**A320/A321**

MODIFICATION No. 23344P2963

TITLE : AIR CONDITIONING - PRESSURIZATION CONTROL - IMPROVE CONTROL
PANEL 25VU.

SERVICE BULLETIN No. : A320-21-1066

PANEL 25VU

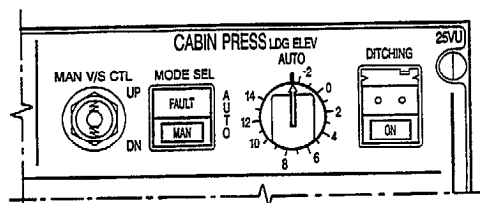
This Service Bulletin proposes replacing, on the panel 25VU, the existing LDG ELEV AUTO potentiometer by an electrically and mechanically interchangeable potentiometer and the associated control knob by a knob with a different shape. The new potentiometer includes the following characteristics :

- a travel reduced from 360° to 300°
- a depressed position allowing no rotation and corresponding to the AUTO mode.

Modification to Equipment in Panel 25VU
Figure 1

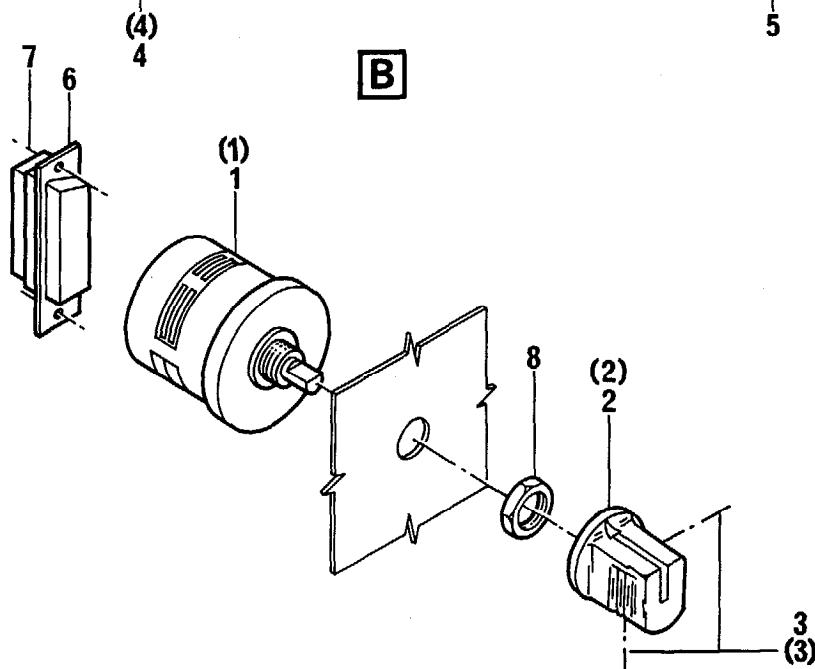
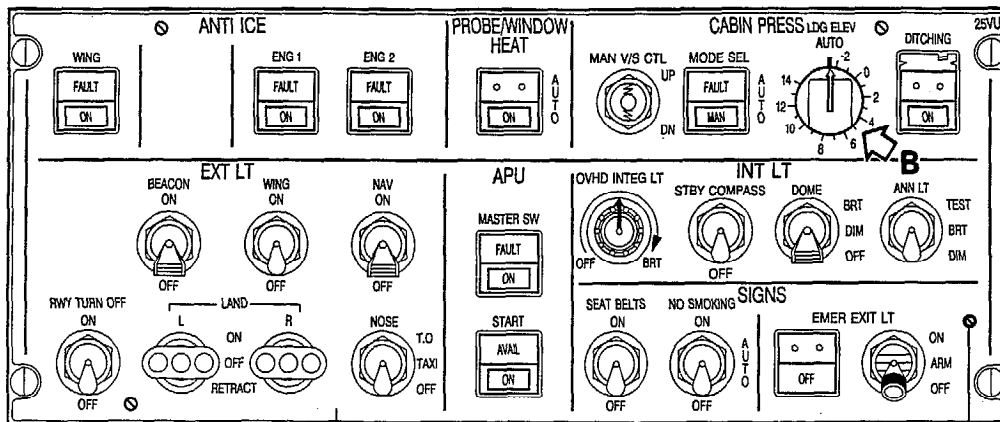
- (a) Remove from the panel 25VU :

4 screws	Item 5 (retain)
1 integrally lighted plate 11LF	Item (4) (discard)

- (c) Remove :

2 screws	Item (3) (discard)
1 control knob	Item (2) (discard)

- (d) Loosen the 2 lock screws Item 7 and disconnect the connector Item 6.

- (e) Remove :

1 nut	Item (8) (discard)
1 selector	Item (1) (discard)

(f) Install :

1 selector	9027-20010	Item 1
1 nut		Item 8

(g) Connect the connector Item 6 and tighten the 2 lock screws Item 7.

(h) Install :

1 control knob	ABS0078-01	Item 2
2 screws	DIN916M3X3A2-70	Item 3

(k) Attach with :

4 screws Item 5
